## SEWAGE DISPOSAL SYSTEM

HOWARD COUNTY HEALTH DEPARTMENT  
BUREAU OF ENVIRONMENTAL HEALTH  
410-313-2640

SUBDIVISION Paternal Gift LOT NUMBER 14 ADDRESS 13501 Paternal Gift Drive

Revised  
Proposed septic layout for  
Lot # 14 Paternal Gift Sub.

Lot 21 49415  
COUNTY #

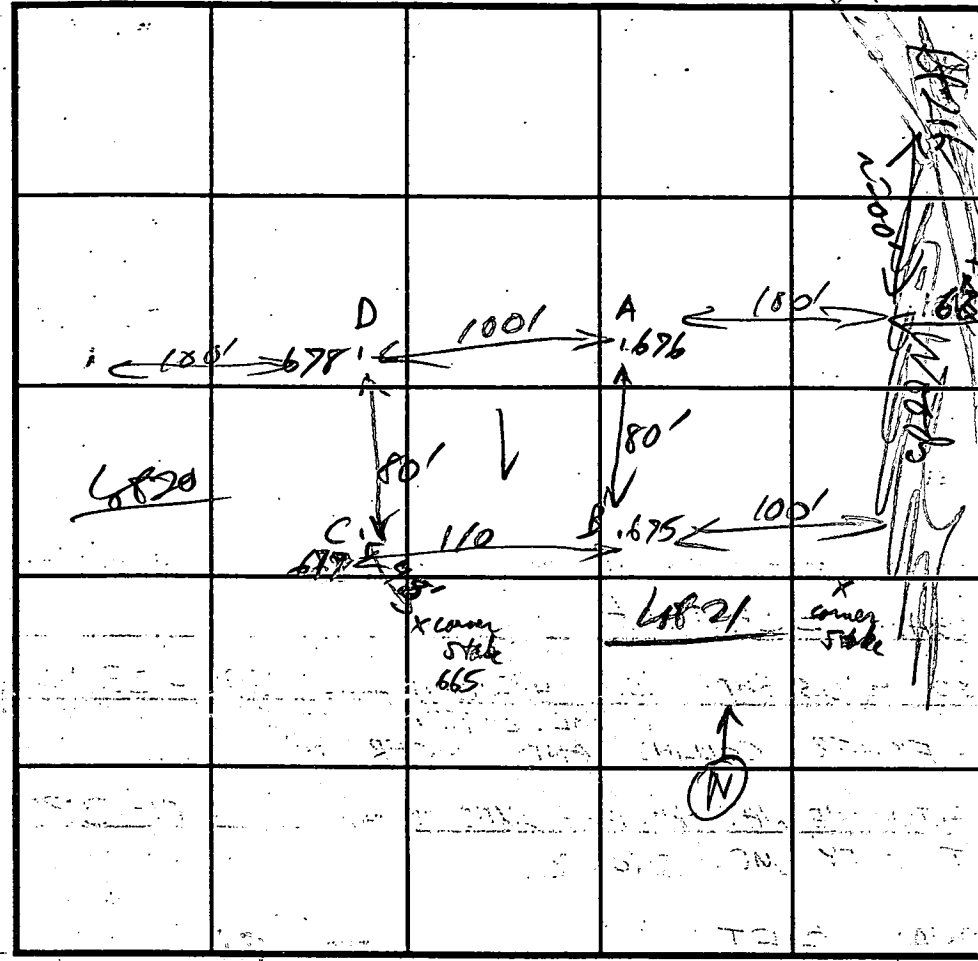
Regarding Lot 14, although wet season testing is preferred, reconfiguration of the SDA, so that the entire 10,000 sq. ft. reserved area is on or at higher elevations than the original lowermost percolation test holes (675B and 677C on the 7-8-93 test notes), may be an acceptable option at this time.

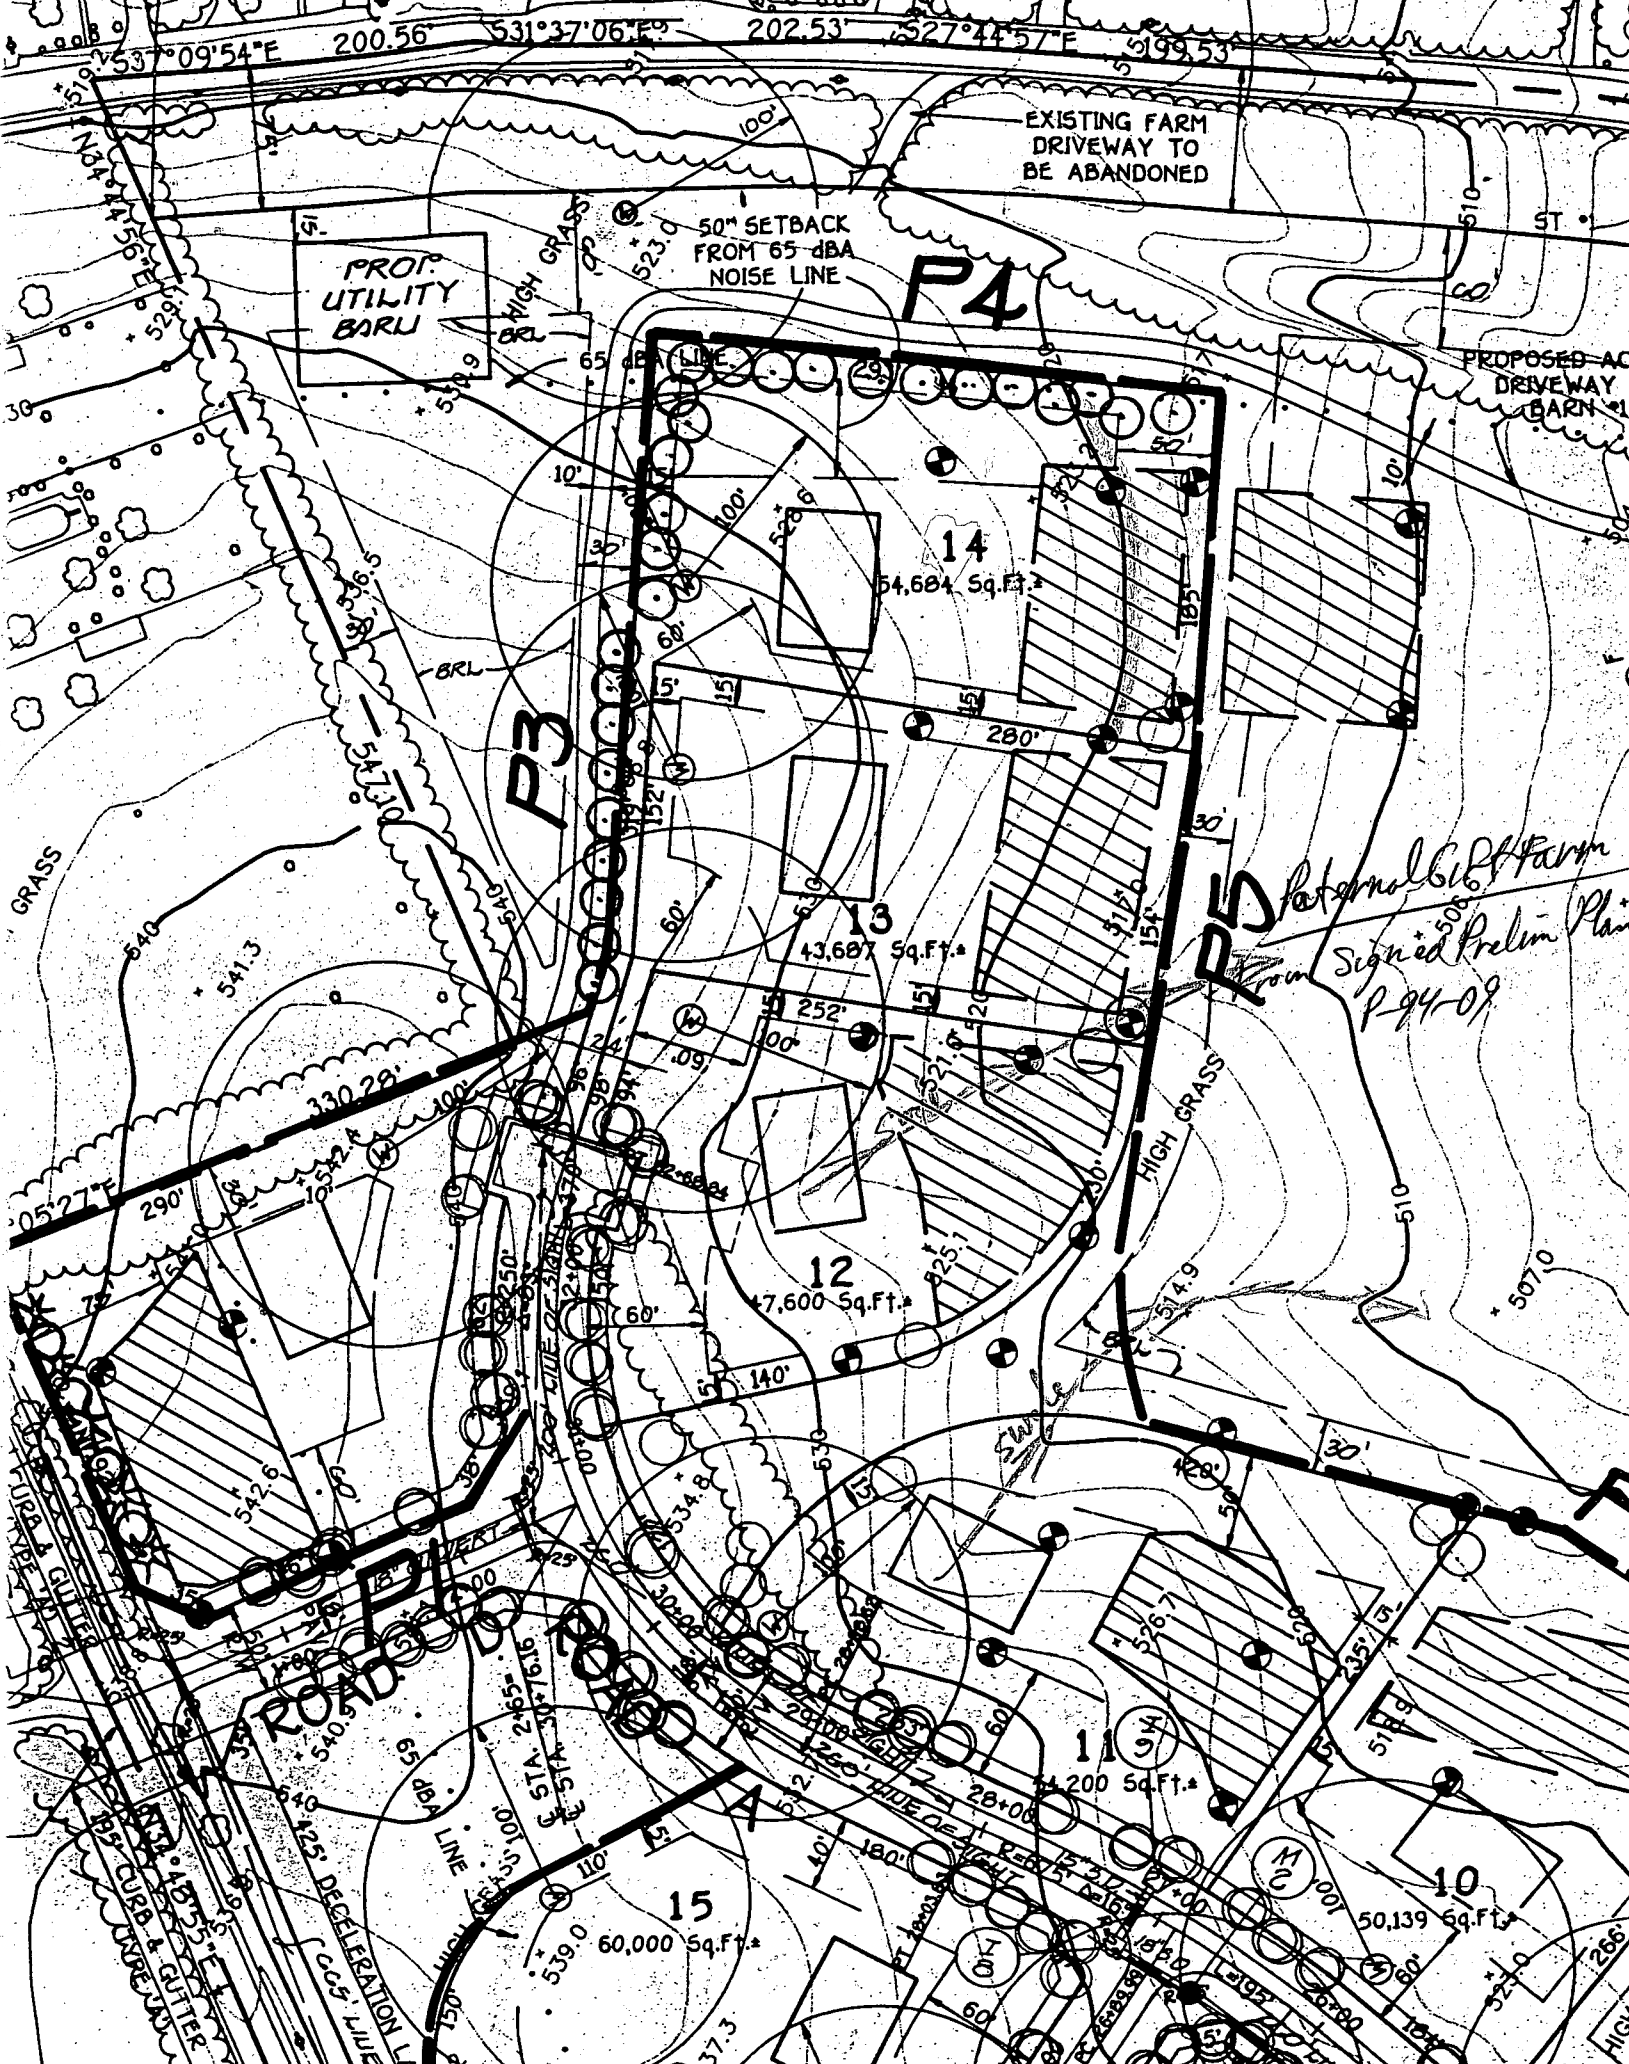
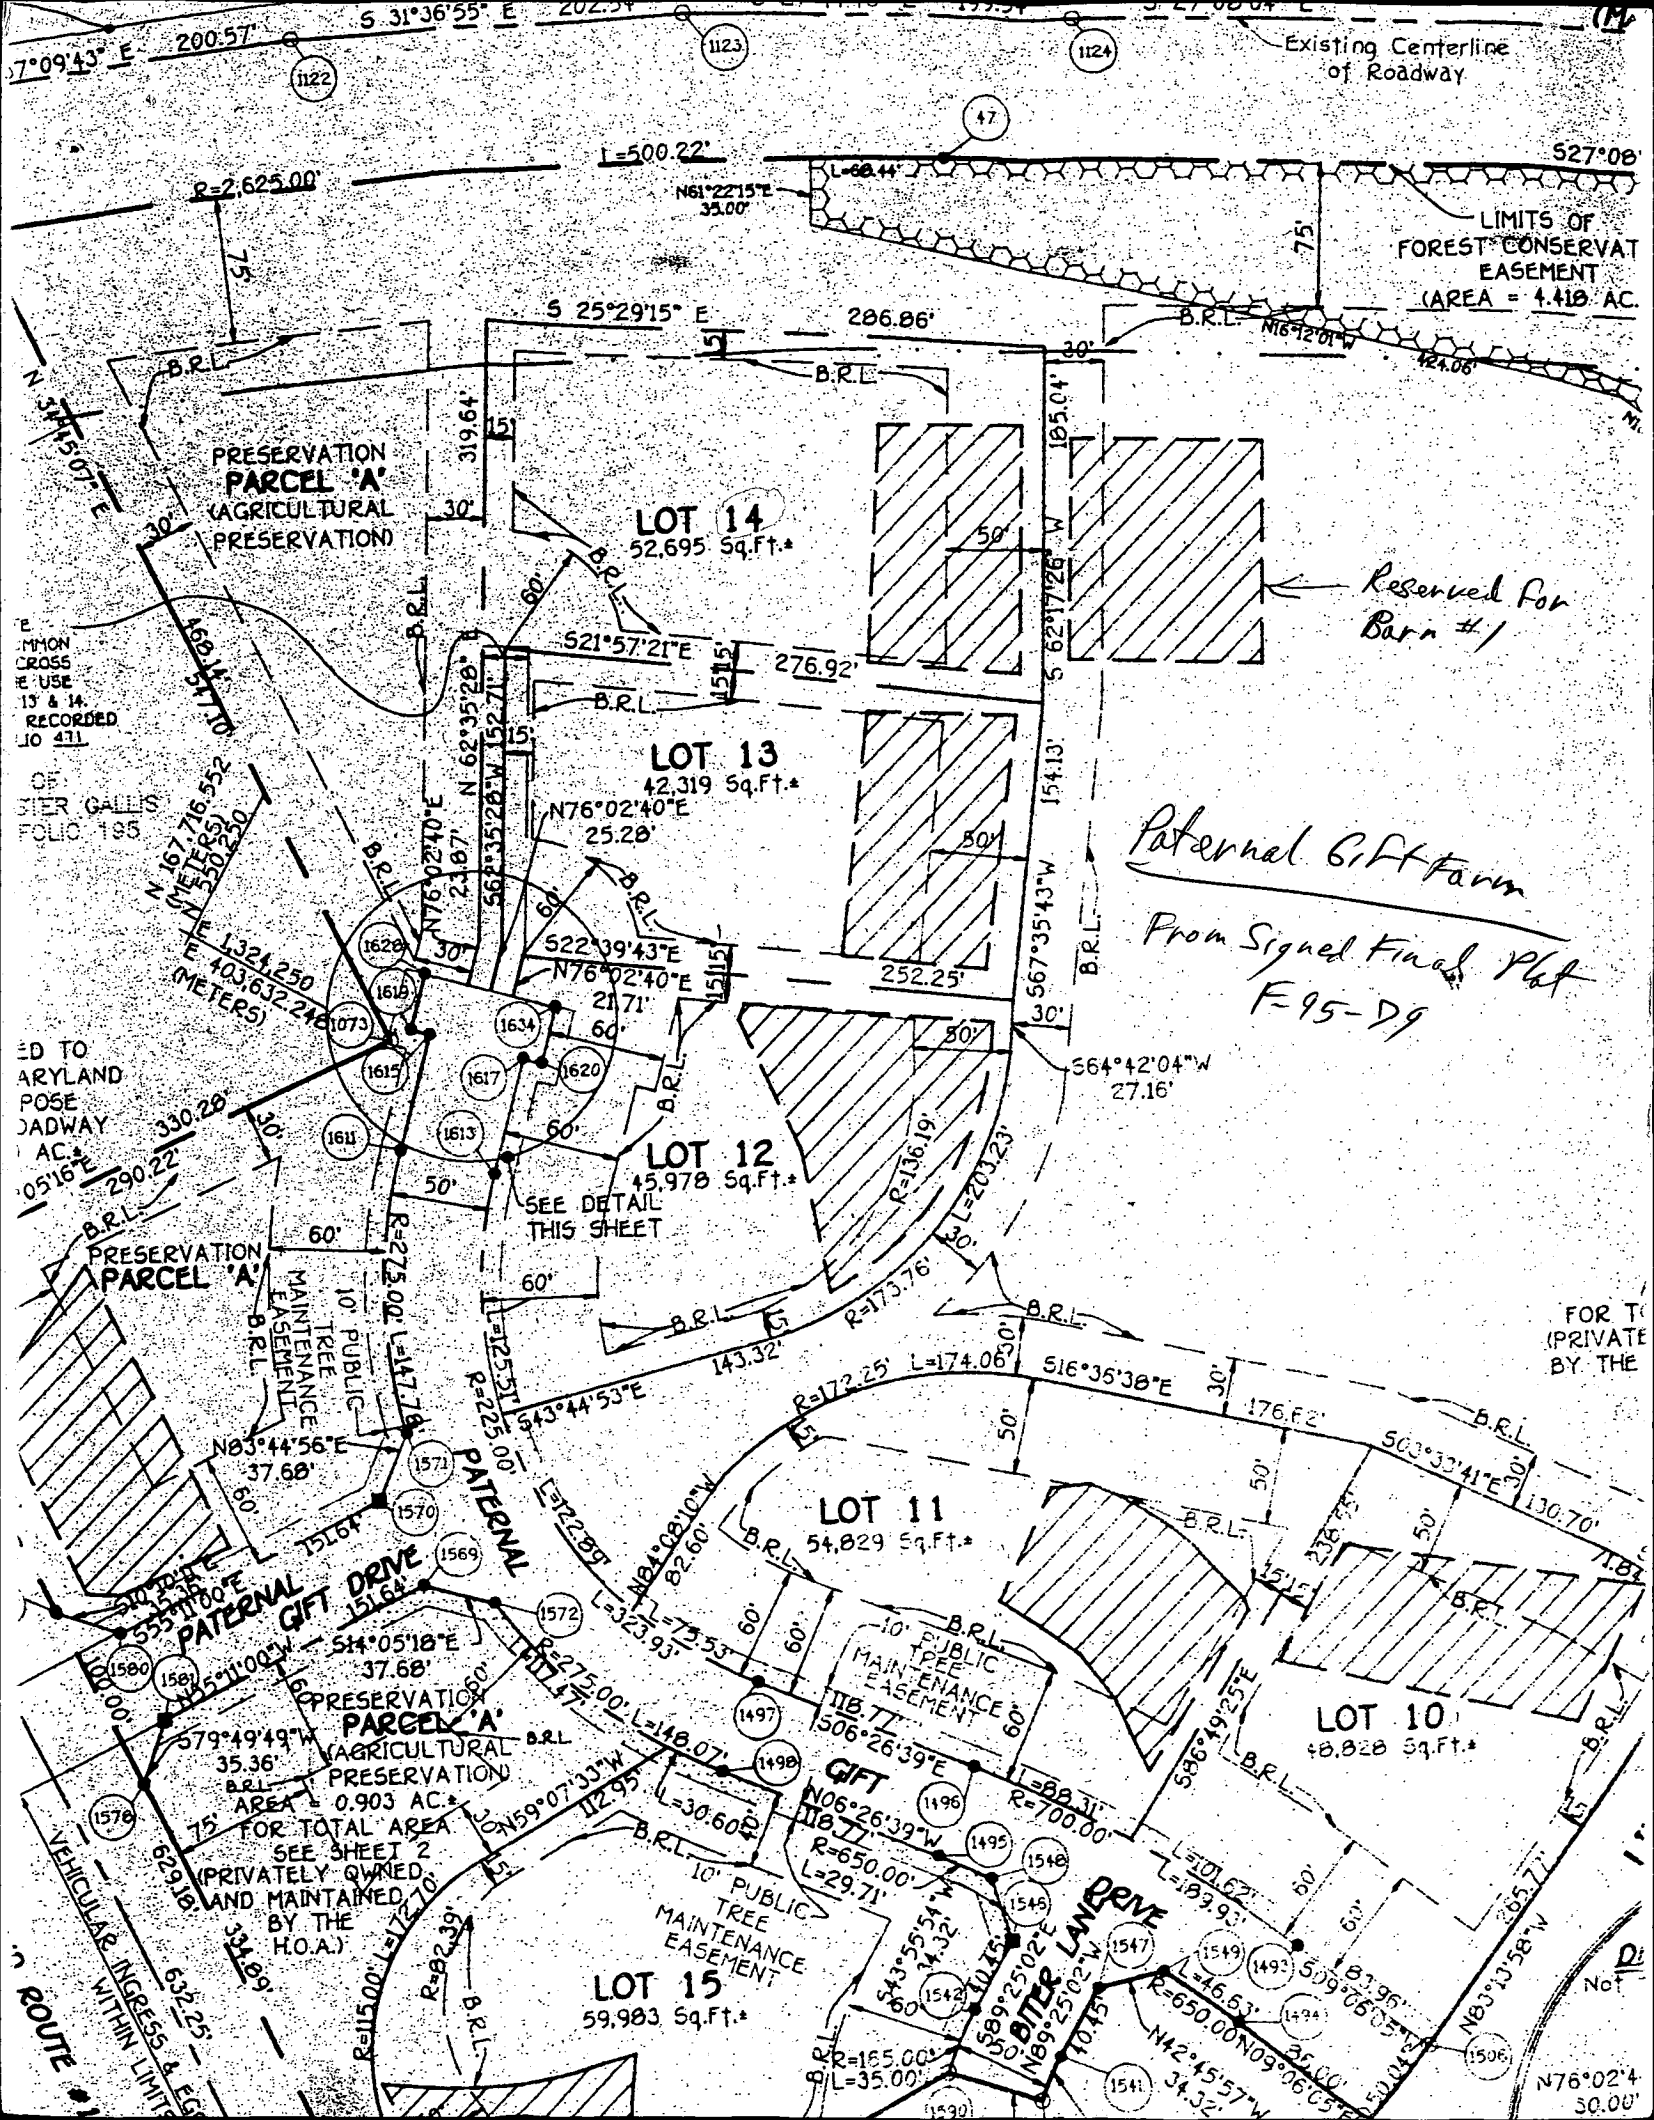
wrote a letter to S.S. for Wed 3/29  
explaining concern about suitability  
of Septic Area after reviewing test  
notes during site inspection. Believe  
it will best serve all interests to  
do a wet season eval in lower part of  
SDA. Now on record reconfigure  
SDA so lower boundary is also at 2  
from original perc holes. Suggest  
eval eval shall also be extended to  
lot 13 & lot 12.  
\* 4/12 See Letter to S.S. & Memo to H. 4/12 M/P/PC/W/S  
C/S

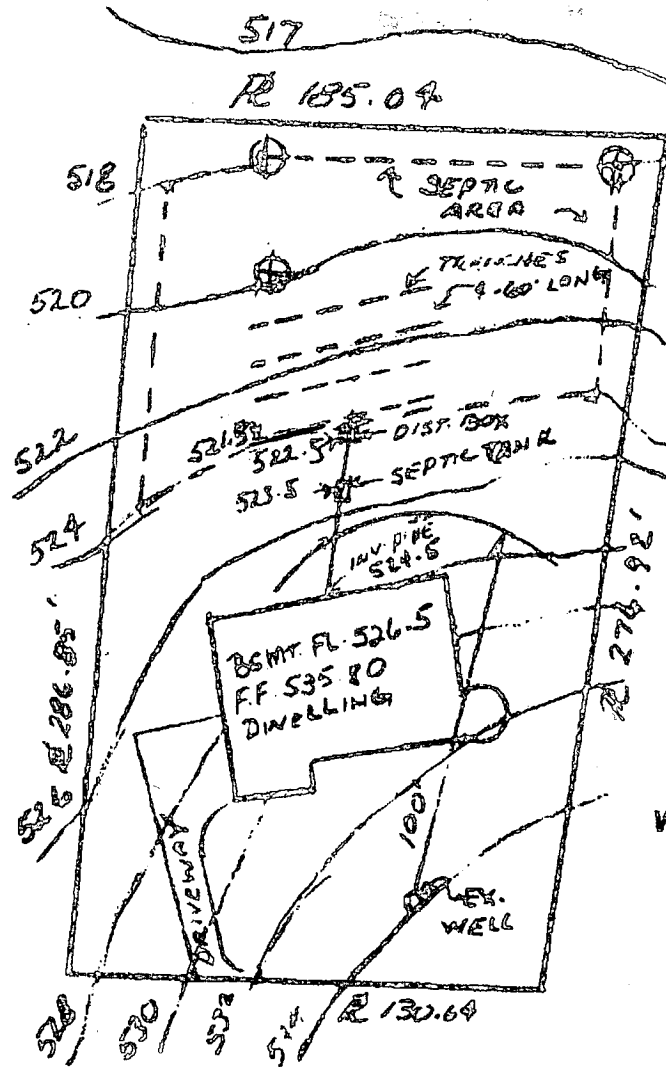
top of 1st trench 521.00 OK but

adjustment to begin @ 54 ft R6. = 518.5 RFP 4/18/00

I released B/L based on this plan but they are to follow up with a plan to scale (so I can write specs correctly) (and to accurately determine well check) and I suggest home corner measurement useful letter when well check needed. RFP 4/18/00

Adjustment to Septic Area Accepted as shown hand drawn 4/18/00

Plans updated to 5 bedroom @ *builder's* request. 8/14/00
